COMPUTIME LTD.				
DRAWN:zj song	DATE:Feb 10,06	SUN005A10A(BASE RF-RX)		
CHK:	DATE:			
APP:	DATE:	A3	RF PART	REV:03
RELEASE:	DATE:	SCALE:NONE	SHEET:2 OF 4

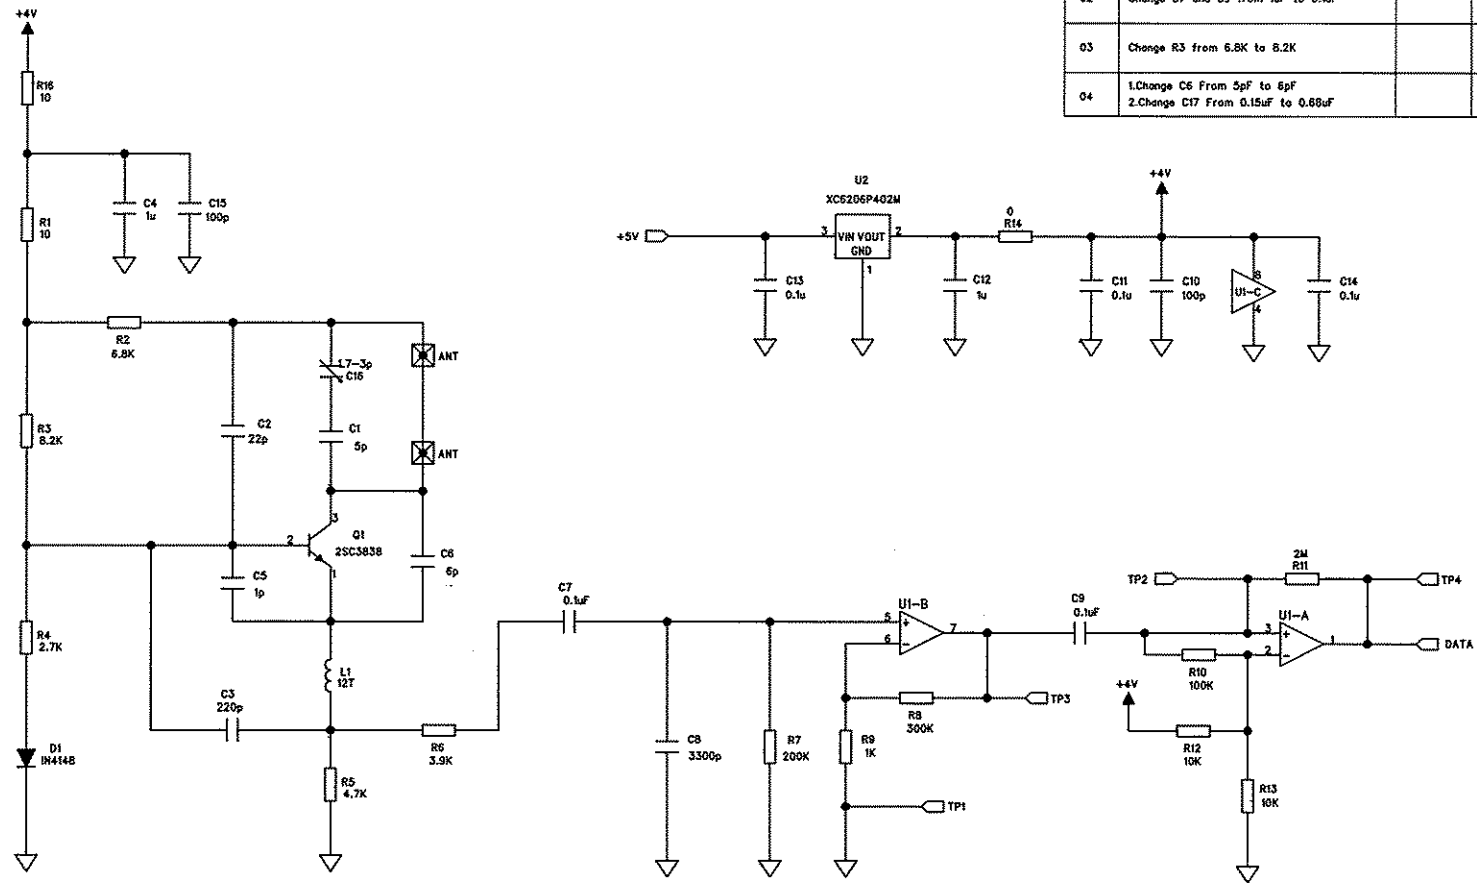
REV	CHANGE DESCRIPTION	APPROVED	DATE
01	Original		Dec 29,04
02	Change C7 and C9 from 1uF to 0.1uF		Sep 12,2005
03	Change R3 from 5.6K to 8.2K		
04	1.Change C6 From 5pF to 6pF 2.Change C17 From 0.15uF to 0.68uF		Mar.27.06
